# Access Compliance Report

## Public Rights-of-Way

Intersection ID: 3564	Main Street: TAVERNAY_PY	Cross Street: TAVERNAY_PY	Location:	W
ADA ID: 3896E250B712	Ramp Type: Perp	Initial Pass/Fail: Fail	Overall Compliance: No	Severity Score: 1.25
Codes/Mitigation Info/Possible Solution		Field Measurements/Component Compliance

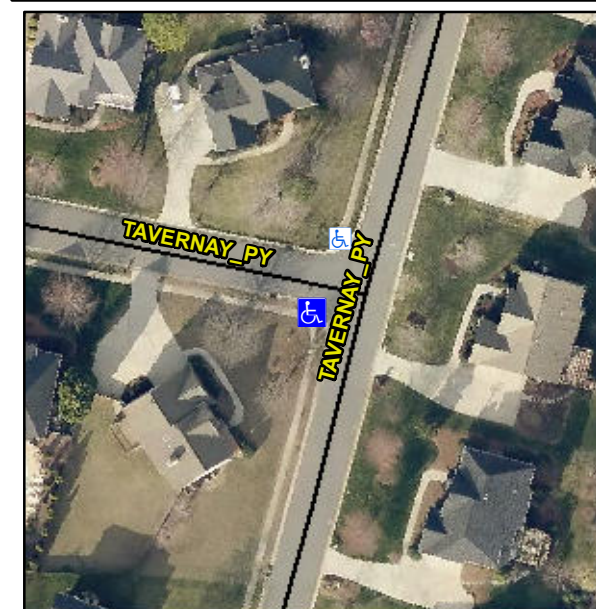
**Remove & Replace Entire Ramp.**

**Not Found, R304.5.3**

Compliance	Description	Data	Compliance	Description	Data
N/A	Ramp Length (in)	48.0	Yes	Ramp Slope (%)	5.5
Yes	Ramp Width (in)	60.0	No	Ramp XSlope (%)	3.9
N/A	Flare Type LT	N/A	N/A	Flare Type RT	N/A
N/A	Flare Slope LT (%)	N/A	N/A	Flare Slope RT (%)	N/A
N/A	Flare Traversable LT?	N/A	N/A	Flare Traversable RT?	N/A
N/A	Landing Length (in)	N/A	N/A	DWS Provided?	N/A
N/A	Landing Width (in)	N/A	N/A	DWS Contrast?	N/A
N/A	Landing Slope (%)	N/A	N/A	DWS Length (in)	N/A
N/A	Landing X Slope (%)	N/A	N/A	DWS Full Width?	N/A
N/A	Landing Curb? (Y/N)	N/A	N/A	DWS Offset (in)	N/A
N/A	Shared Landing?	N/A			
N/A	Gutter Ponding?	N/A	N/A	Gutter Slope (%)	N/A
N/A	Gutter Lip Ht (in)	N/A	N/A	Gutter X Slope (%)	N/A
N/A	Painted X Walk1?	No	N/A	Painted X Walk2?	N/A
	X Walk 1 Direction	To NE		X Walk 2 Direction	N/A
N/A	X Walk 1 Width (in)	N/A	N/A	X Walk 2 Width (in)	N/A
	X Walk 1 Slope (%)	1.7		X Walk 2 Slope (%)	N/A
	X Walk 1 X Slope (%)	3.8		X Walk 2 X Slope (%)	N/A
